# Comhairle Chontae Atha Cliath Theas

## **Record of Executive Business and Chief Executive's Order**

**Reg. Reference:** SDZ21A/0023      **Application Date:** 20-Dec-2021

**Proposed Development:** 455 residential units (including a mixture of 2 and 3 storey semi-detached and terraced houses, and duplex units and apartments in 3 and 4 storey blocks), new internal roads and footpaths, site access, public open space, car parking, cycle stores, landscaping, bin stores, foul and surface water drainage, boundary walls and fences, ESB substations and all associated site development works. Private and semi-private open space to serve the proposed units will be provided in the form of balconies, terraces and gardens; including revisions to the permitted / under construction Celbridge Link Road (part of Loop Road 3), permitted under Reg. Ref SDZ17Af0009, associated with the provision of access to the development, parallel parking bays, and public lighting; 58 two bed, two storey, terraced houses (Type E1, E2, E3, J1 & J2); 6 three bed, two storey, semi-detached houses (Type 11); 190 three bed, two storey, terraced houses (Type A 1, A2, A3, B1, 82, C1, C2, C3, D1, D2, F1, F2, 11 & 12); 5

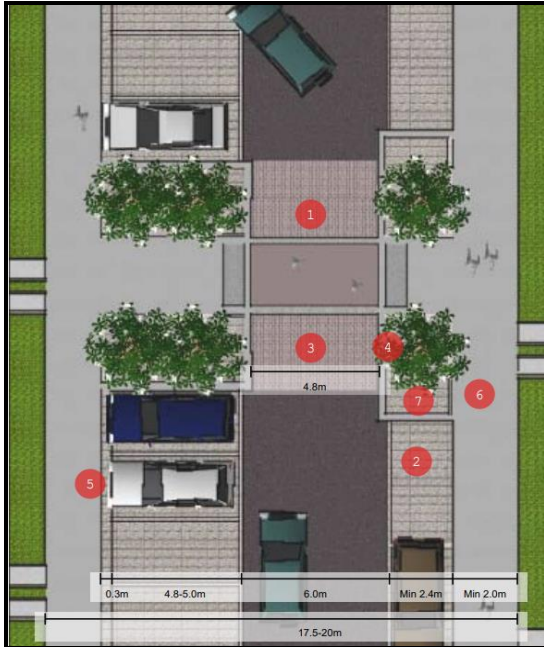
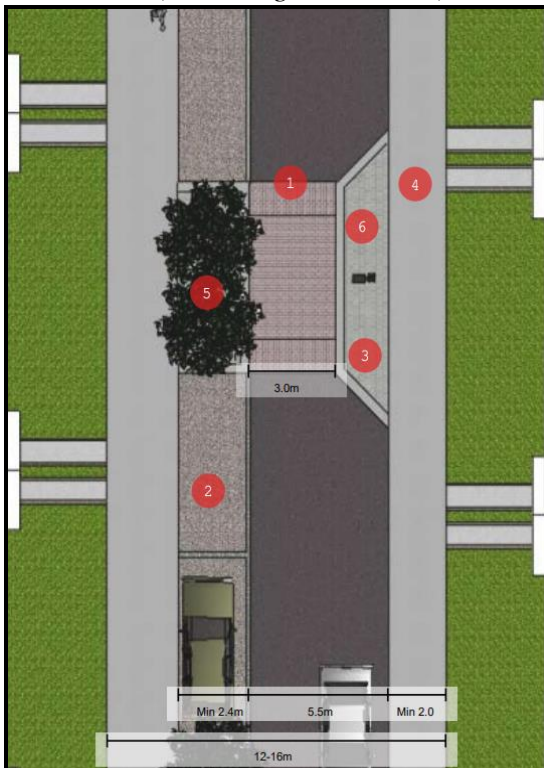
From the layout plan, there appears to be two types of secondary streets – a car based street and a homezone. It is not clear how these streets align with the ASCG hierarchy. The below shows indicative layouts for side streets and back streets:

The applicant is requested to provide a road layout plan clearly indicating street typologies. Each type of street should meet the relevant design requirements in terms of parking, pedestrian/cycle movement, crossings and street trees. **Additional information** is required. It is noted that some perpendicular parking associated with the secondary streets is visible from the avenues – the applicant is requested to redesign these areas via **additional information**.

(C) The applicant is requested to provide a road layout plan clearly indicating street typologies. Each type of street should meet the relevant design requirements in terms of parking, pedestrian / cycle movement, crossings and street trees. Cross sections for each road type should ensure correct spacing for cycle lanes and parallel and perpendicular parking should be provided.

*Figure 1 SDZ road layout and proposed layout*

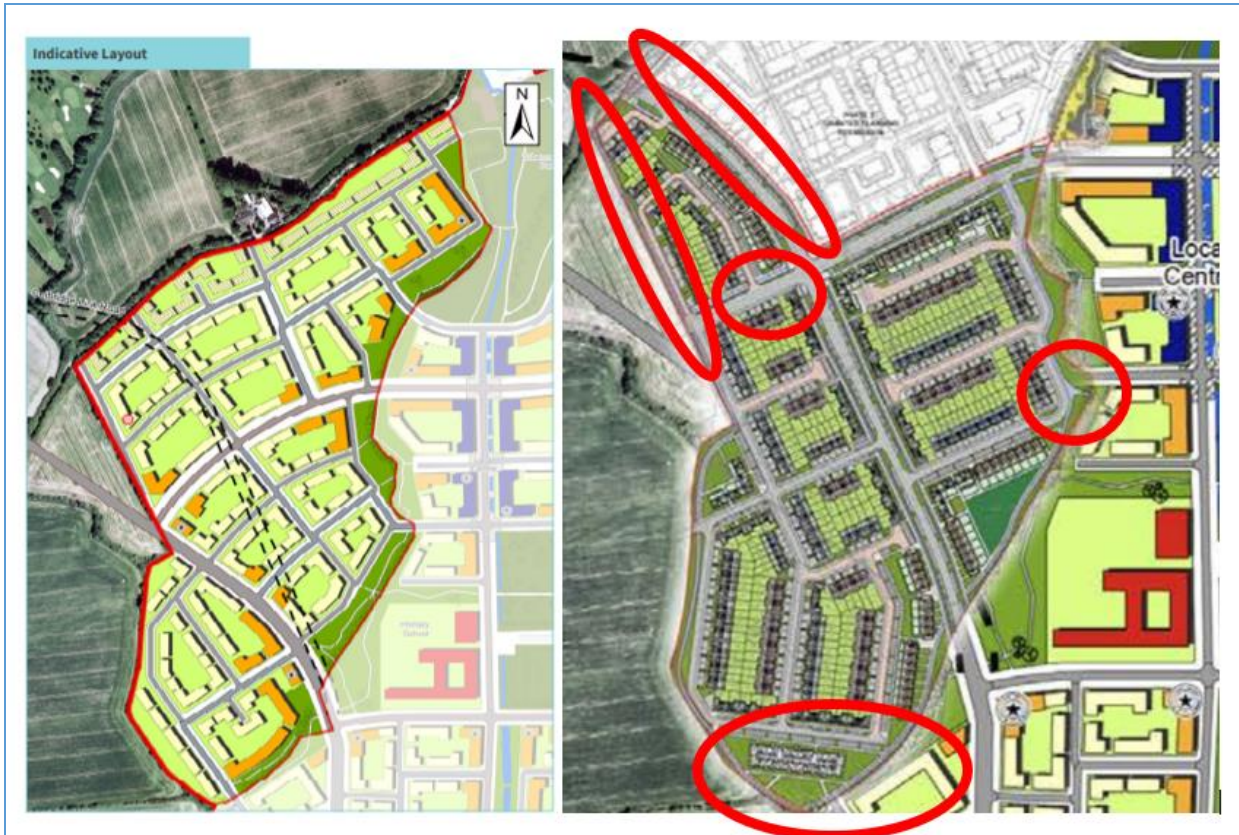
*The main vehicle access locations are from the Celbridge link road running north south. There is another major access from the Adamstown Boulevard from the east. The access links provided for in SDZ17A/0009 should correspond to the access points identified in this development. The street cross sections should match the proposed Celbridge Link road and follow the layout as approved i.e. on street parking bays, cycle lanes etc.*

Figure 2 road layout from SDZ17A/0009

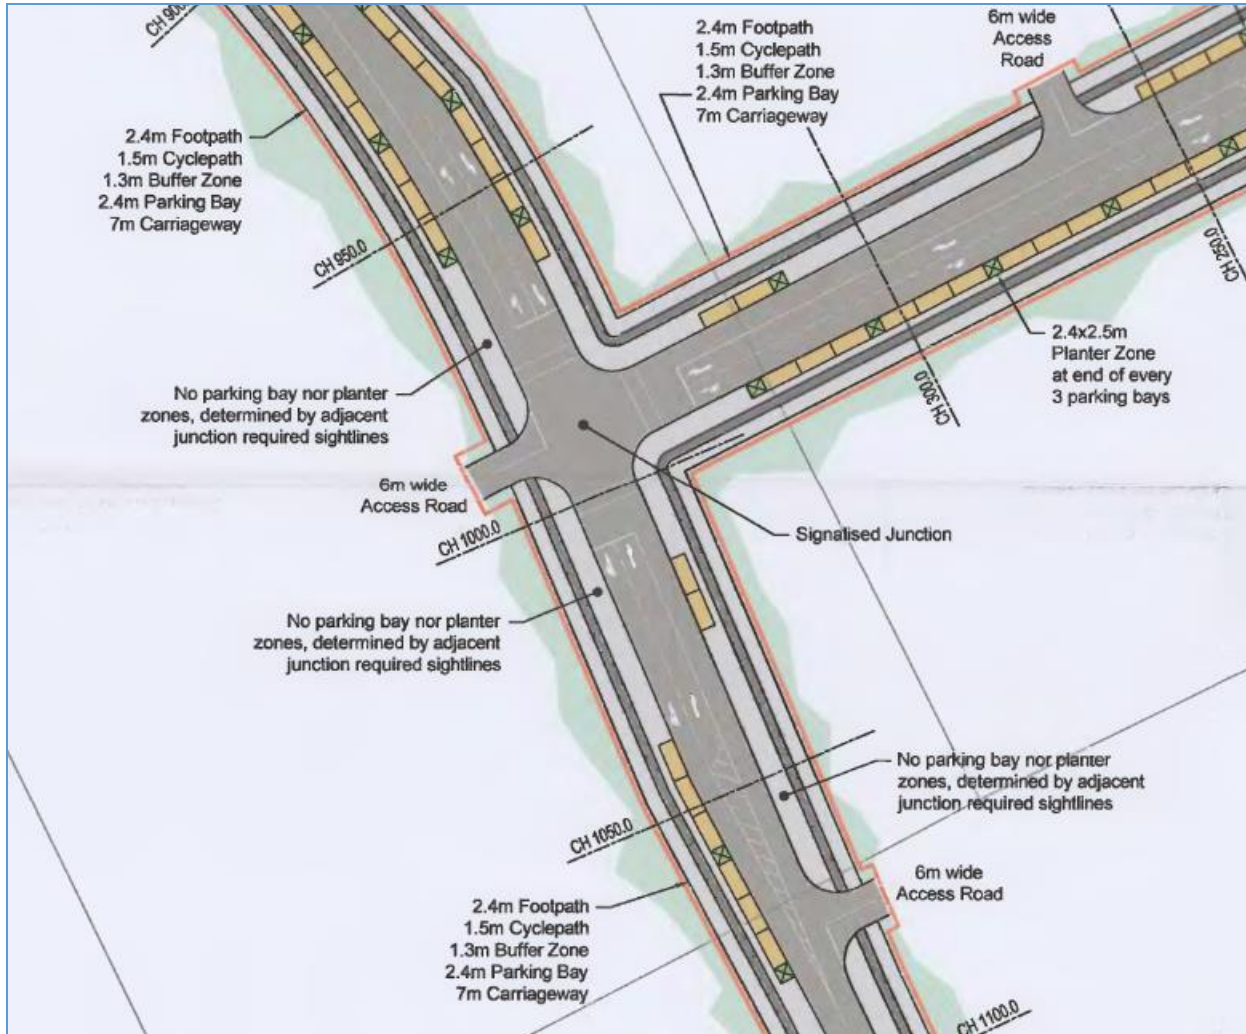
The internal road layout has been provided. The applicant should provide the road cross sections for each road type and ensure the design of roads and streets within the Adamstown SDZ are in accordance with DMURS. Cross section for each road type should ensure correct spacing for cycle lanes and parallel and perpendicular parking. The details of access roads and crossing points should also be submitted showing dimensions of corner radii, road widths etc.

*Figure 4 link to west development.*

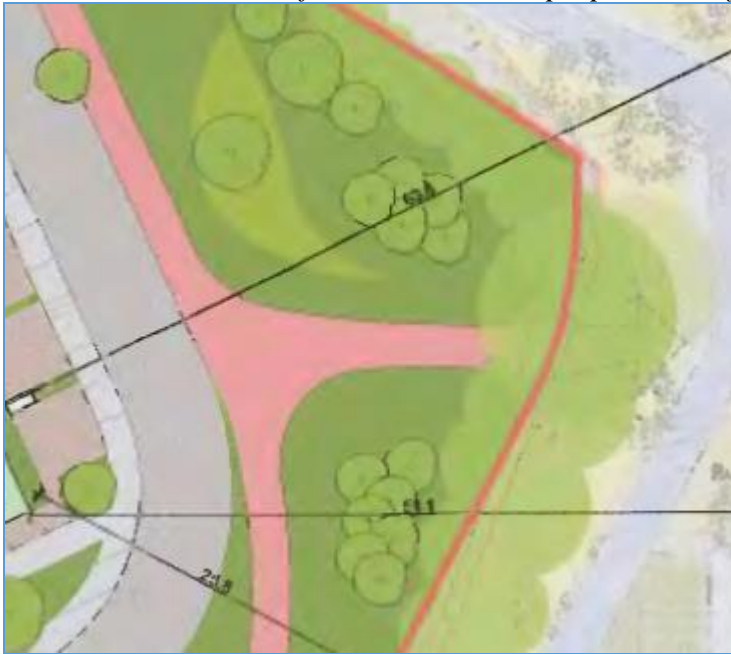
*The link to the east Figure 4, is shown as pedestrian this is vehicular in the SDZ tile. This is a link to the proposed school and shopping to the west of the development and crosses the linear park. This link should be verified and match the proposed link from the neighbouring development.*

Figure 8 Bike shelter

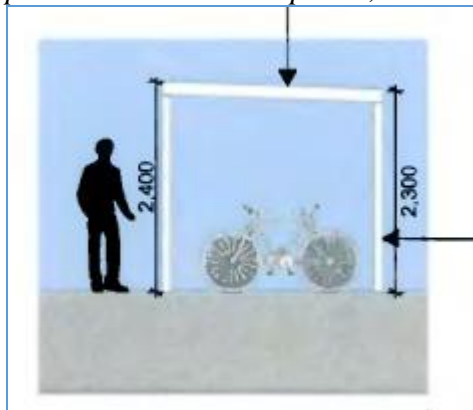
Details of bicycle parking shelters has been provided, Figure 8. The location of the shelters has also been provided. The applicant should provide a statement on the quantity of bicycle parking provided at the development, to ensure the amount is consistent with the apartment guidelines.

(9) The applicant is requested to provide a statement on the quantity of bicycle parking provided at the development, to ensure the amount is consistent with the apartment guidelines.
